TO: Power Plant Siting Review Committee  
FROM: Hamilton S. Oven, Jr. *Hso*  
DATE: June 12, 1985  
SUBJECT: South Broward County Resource Recovery Project  
Sufficiency Responses

Re: South Broward County Resource Recovery Project, Inc.  
Power Plant Siting Application, PA 85-21;  
OGC File No. 85-0367; DOAH Case No. 85-1166

SOUTH BROWARD COUNTY RESOURCE RECOVERY PROJECT  
POWER PLANT SITING APPLICATION, PA 85-21  
OGC FILE NO. 85-0357, DOAH CASE NO. 85-1166

APPLICANT RESPONSES TO FLORIDA DER INQUIRY OF  
APRIL 19, 1985

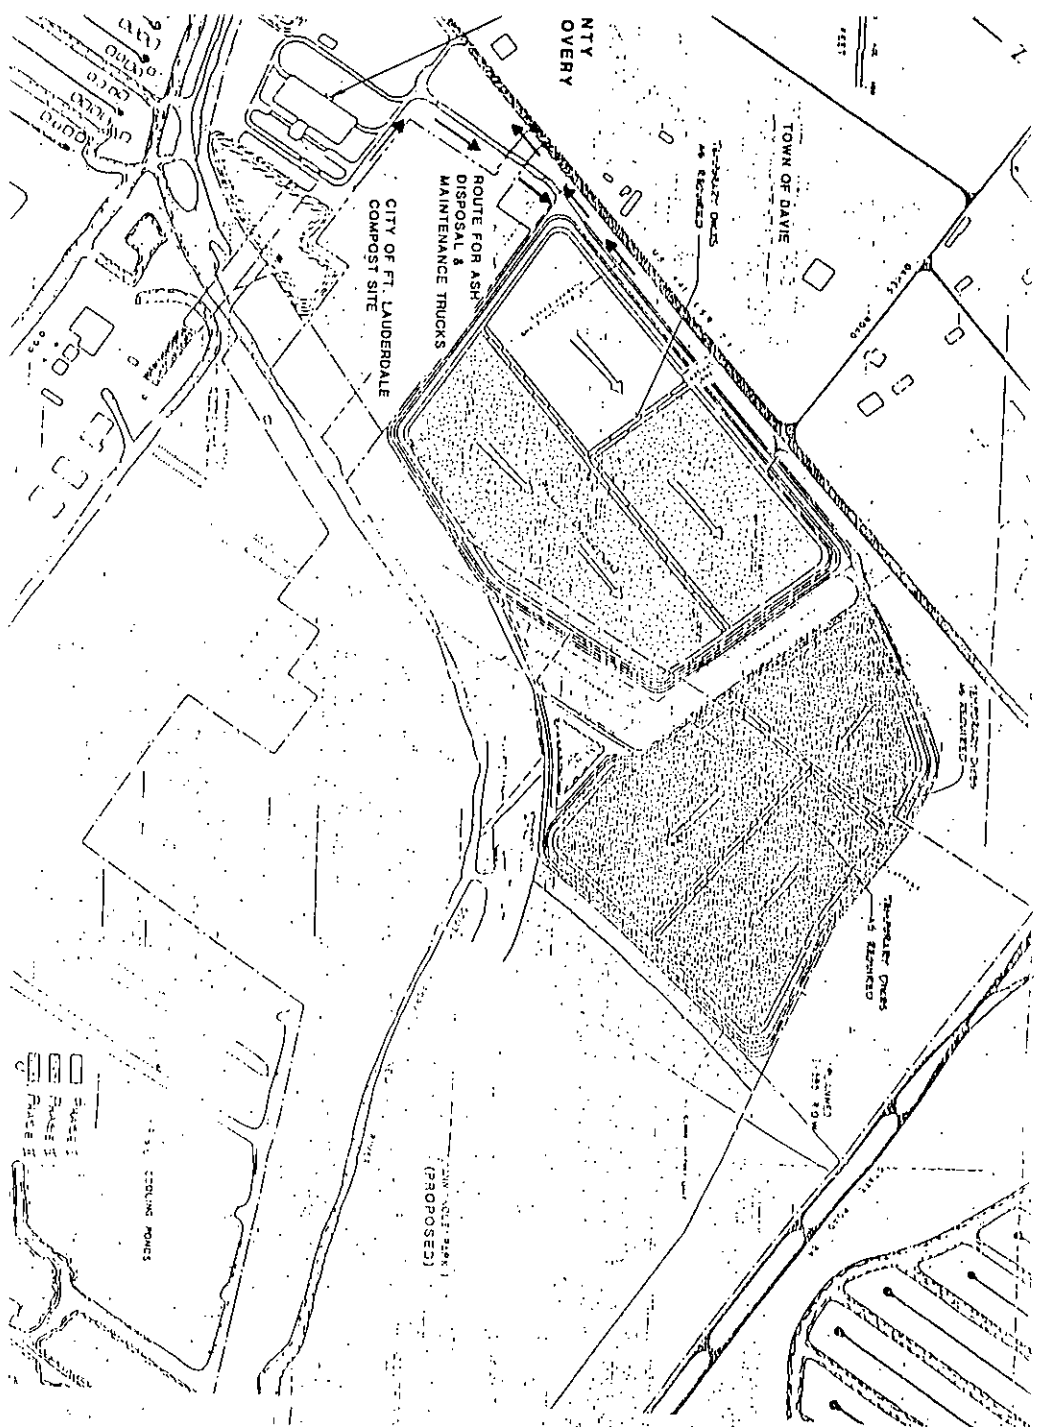
*Question 3: Figure 2.1.3 (see attached) fails to show how ash disposal trucks or maintenance trucks will get from the RRF to the landfill.*

**Response:** Revised Figure 2.1.3 (see attached) shows the truck flow from the Resource Recovery Facility to the landfill.

FIGURE 2.2.1

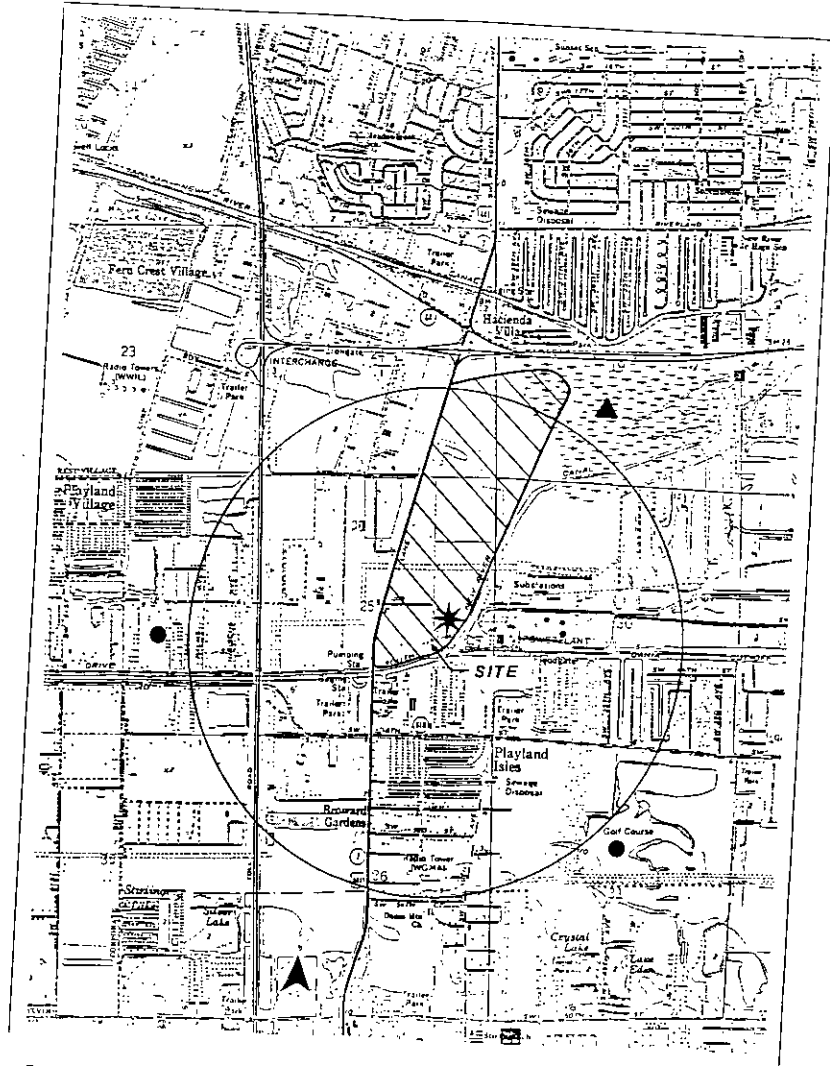
Question 1: *The 1:24000 governmental jurisdiction map required by Section 2.2.1 needs to be provided.*

Response: Figure 2.2.1.2 (see attached) represents the 1:24000 governmental jurisdiction map required by Section 2.2.1.
